03-15-24

Addendum No.: 1

Project:CCCL Maintenance Fire Alarm<br/>UpgradeAES Project No.:23101-185, DCS #2105B

#### Sheet E0.01 Maintenance Site Plan- Fire Alarm

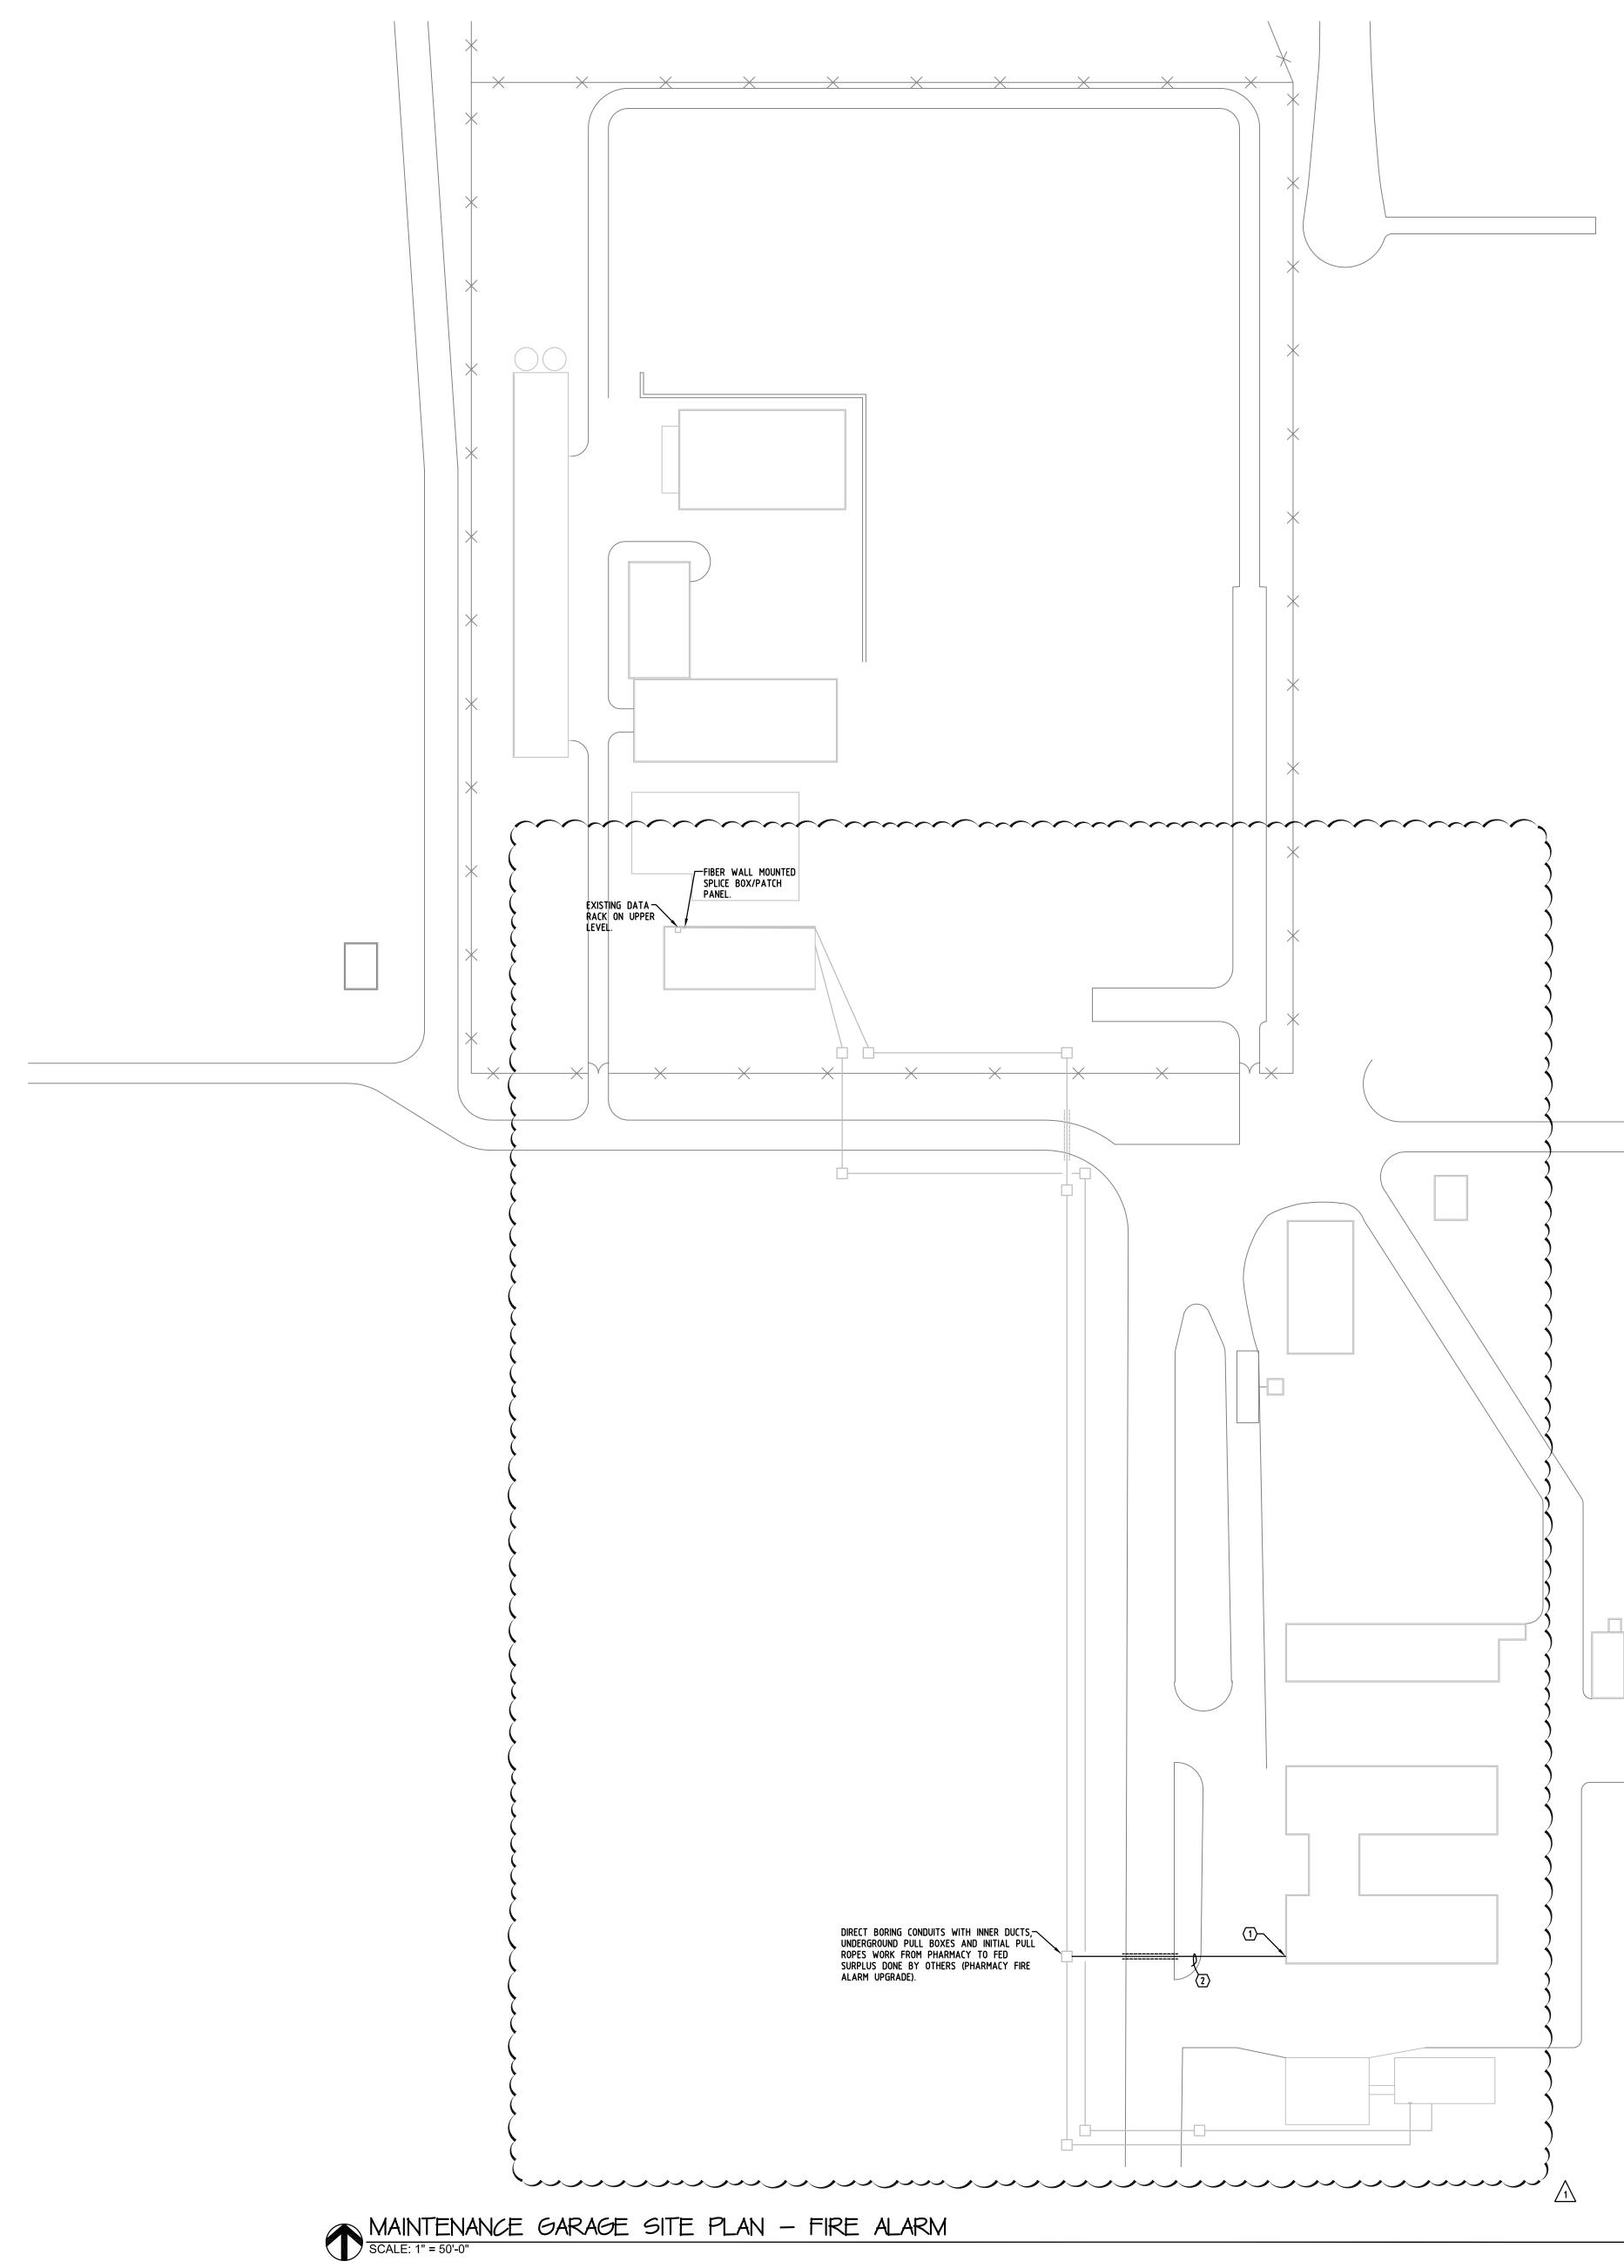
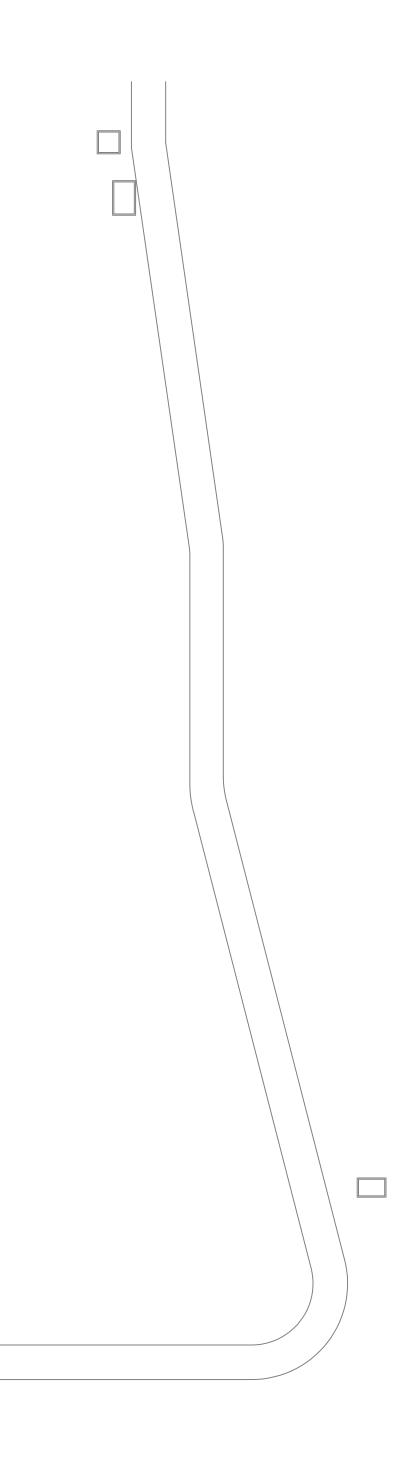
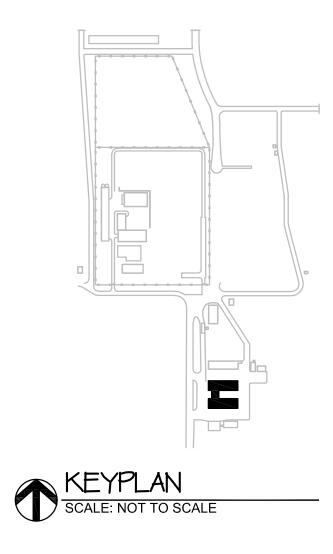
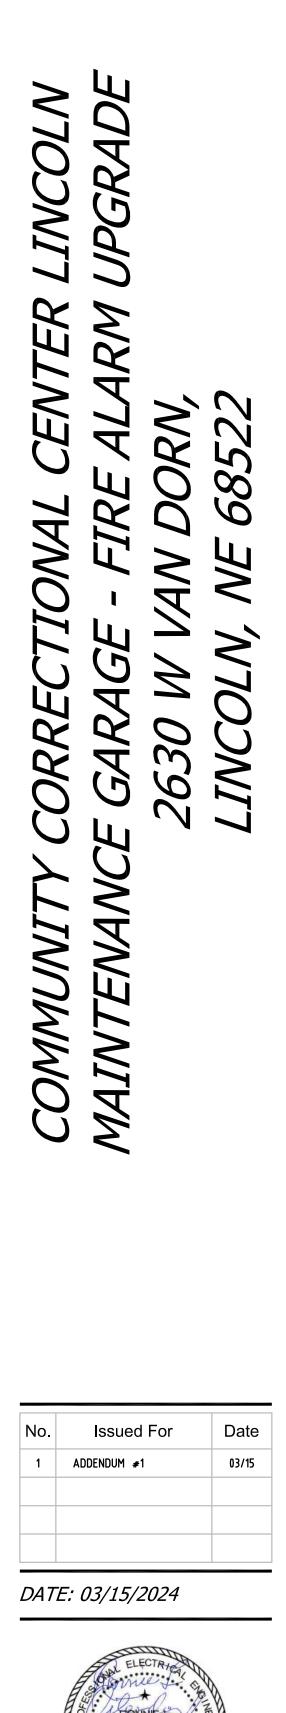
2. How to break down for the direct boring installation shown on the site plans, since that are shown the same as the maintenance building. Under the pharmacy project base bid, the site direct bore conduit installation is for the system shown from the pharmacy to the Federal Surplus building, includes all inground boxes and crossing roads twice. For the Maintenance building fire alarm upgrade project, the base bid shall include the directional bored for the CCCL maintenance building. The 24 strands single mode fiber (and Pull rope) is installed under the respective base bid for each facility to Fed surplus upper-level new patch panels.

12. Reflects note 2 above on the portions of the site work to be done under the base bid. See attached Drawing.
